DESCRIPTIVE REPORT
(HYDROGRAPHIC)

Type of Survey HYDROGRAPHIC
Field No. FA-10-1-71
Office No..... H-9207

State Alaska
General Locality Katalla Bay
Locality Martin Islands to Strawberry Point

PACIFIC MARINE CENTER
VERIFIER'S REPORT

UNITED STATES
ALASKA - SOUTH COAST
CONTROLLER BAY
 Mercator Projection
 Scale 1:100,000 at Lat. 60°
SOUNDINGS IN FATHOMS
AT MEAN LOWER LOW WATER

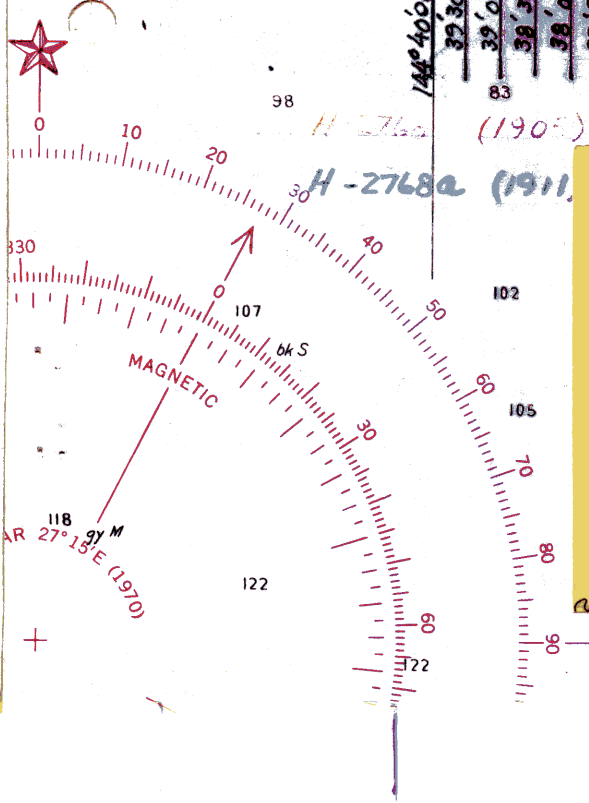
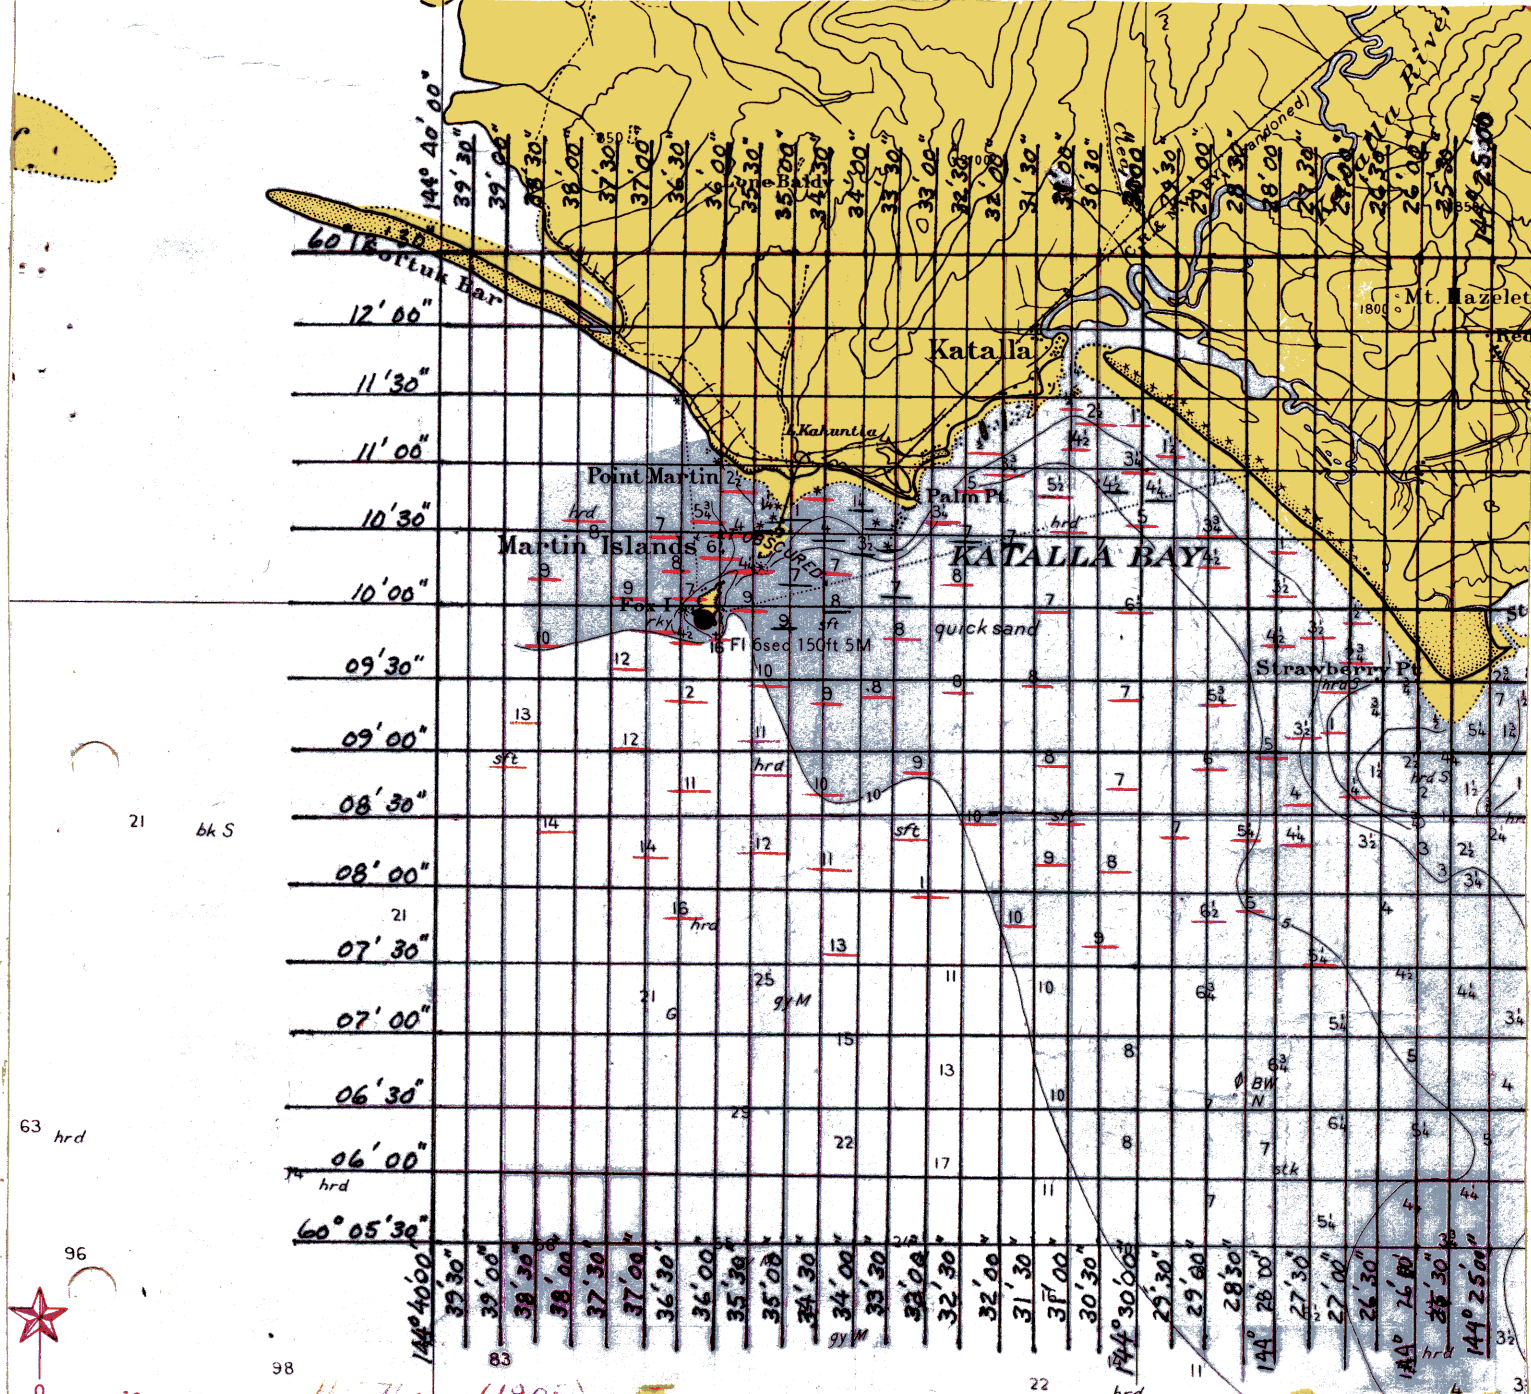
The source was determined for most charted features and are designated as follows on the attached chartlet:

Red	H-2768 (1905)
Blue	H-2768a (1911)

Because charted hydrography and offshore features (except for PSR items) were identified as originating with prior surveys, discrepancies have been disposed of in Section VI, "Comparison with Prior Surveys". It is recommended that H-9207 supersede charted hydrography in the common area.

PSR item #1, the engine from a wreck, reported in 1910 was not investigated by a sounding vessel. The location at Lat. $60^{\circ}11.0'$, Long. $144^{\circ}31.3'$ falls on the southerly edge of a small holiday with no sounding lines passing over the designated area. The indicated location of this item is arbitrary and falls inside the 2 fm. curve at this time (1971). Recommend this item not be charted *because of age and bottom changes*

PSR item #2, quicksand, reported in chart letter No. 69 of 1926 was not specifically investigated. Two bottom samples taken in the vicinity at Lat. $60^{\circ}09.8'$, Long. $144^{\circ}32.2'$, indicate grey sand and mud with no definite determination of quicksand. Recommend note continue to be charted.

A 16 fm. depth at Lat. $60^{\circ}09.7'$, Long. $144^{\circ}36.0'$ is apparently an error in chart compilation from H-2768 (1905). Soundings at this location on H-9207 indicate 10.2 fms. Recommend the 16 fm. be deleted.
